Access Compliance Report

Public Rights-of-Way

(Curb Ramps)

Intersection ID: 13502	Main Street: WEST_BV	Cross Street: WILMORE_DR	Location: NE
ADA ID: D5E54883A406	Ramp Type: PerpDiag	Initial Pass/Fail: Fail	Overall Compliance: No
Codes/Mitigation Info/Possible Solution		Field Measurements/Component Compliance

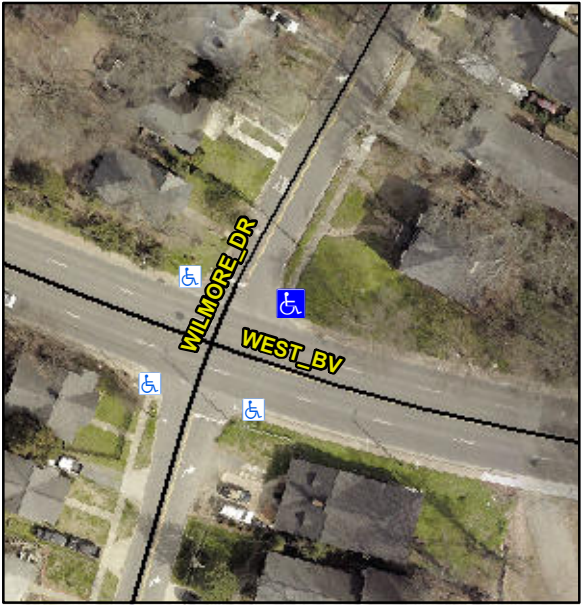
Possible Solutions:						
	Remove & Replace Curb Ramp With Two New Directional Ramps or Equivalent.	Compliance	Description	Data	Compliance	Description	Data
<p>Surveyor Notes:</p> <p>N/A</p>	<p>PROW/ADA:</p> <p>Not Found, R304.5.1, R304.2.2, R304.5.3</p>	N/A	Ramp Length (in)	59.0	No	Ramp Slope (%)	10.1
		No	Ramp Width (in)	41.0	No	Ramp XSlope (%)	10.0
<p>Street 1 Name</p> <p>Stop Condition-Street 2</p> <p>Street 2 Name</p> <p>Stop Condition-Street 1</p>	<p>WILMORE DR</p> <p>StopSign</p> <p>WEST BV</p> <p>None</p>	N/A	Flare Type LT	N/A	N/A	Flare Type RT	N/A
		N/A	Flare Slope LT (%)	N/A	N/A	Flare Slope RT (%)	N/A
		N/A	Flare Traversable LT?	N/A	N/A	Flare Traversable RT?	N/A
		N/A	Landing Length (in)	N/A	N/A	DWS Provided?	N/A
		N/A	Landing Width (in)	N/A	N/A	DWS Contrast?	N/A
		N/A	Landing Slope (%)	N/A	N/A	DWS Length (in)	N/A
		N/A	Landing X Slope (%)	N/A	N/A	DWS Full Width?	N/A
		N/A	Landing Curb? (Y/N)	N/A	N/A	DWS Offset (in)	N/A
